Product Change Notification: DSNO-04BWYN422

CCB 8227 Initial Notice: Qualification of Matte Sn as a new lead plating for MIC33153-4YHJ-TR, MIC33153YHJ-TR, MIC3385-1.5YHL-TR and MIC3385YHL-TR catalog part numbers (CPN) available in 14L TDFN (3.5x3.0x1.15mm) and 14L VDFN (3.5x3.0x1.15mm) packages at UNIS assembly site.

CCB 8227
Pre and Post Change Summary
PCN #: DSNO-04BWYN422

Lead-Frame Comparison

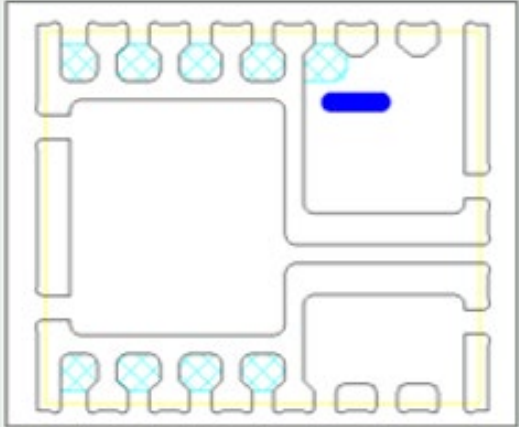
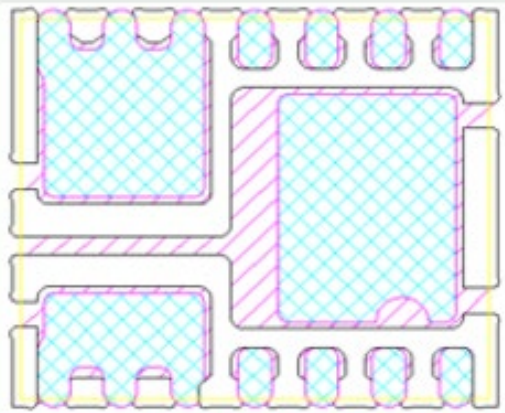
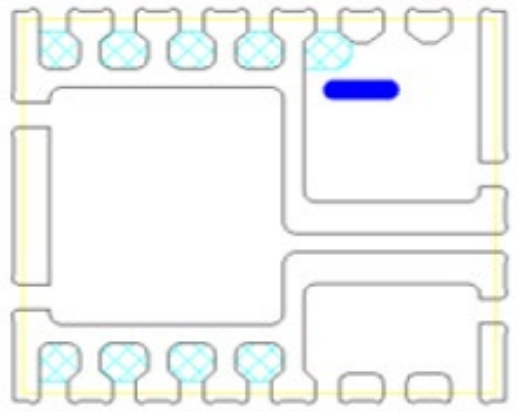
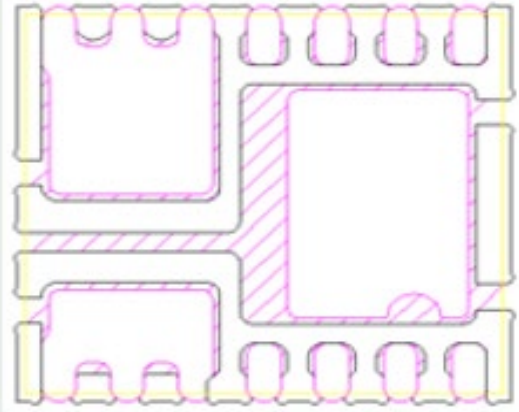
***Note 1:** Leadframe Top side change from “Selective PPF” to “Selective Ag Plating”; Bottom side change from “Selective PPF” to “Bare Cu”.
